Amphenol Canada Corp -Product Change Notice (PCN)

PCN-1448 Comparison

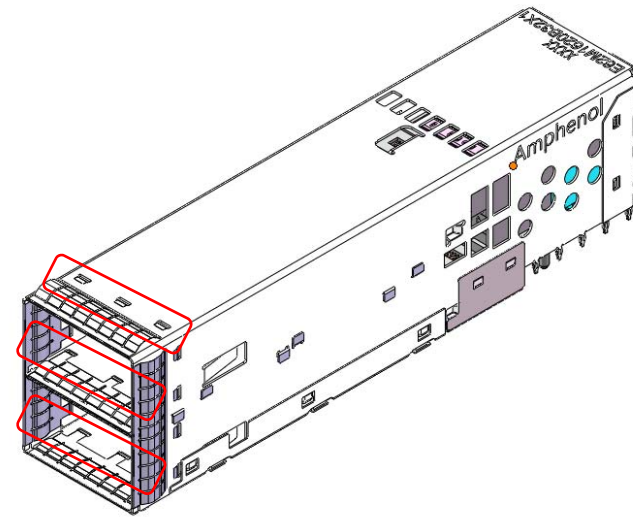
PCN Date	November 21, 2019
Supplier Name:	Amphenol
Amphenol Canada PCN-DN Number	PCN-1448
Description of Change	Change the EMI spring finger of the cage
Reason for Change	Use the improve EMI spring finger to solve the damage issue when plug inserted
Summary of changes between new and old part	See attached for detail
Traceability guidelines (lot code / date code, markings, ship date...)	Date code
Last Time Buy Date	1/15/2020
Datasheet attached? & Filename(s)	Attached new drawings
Qual Test data attached? & Filename(s)

The Hook Qty. Change from 2Pcs to 3Pcs/Port
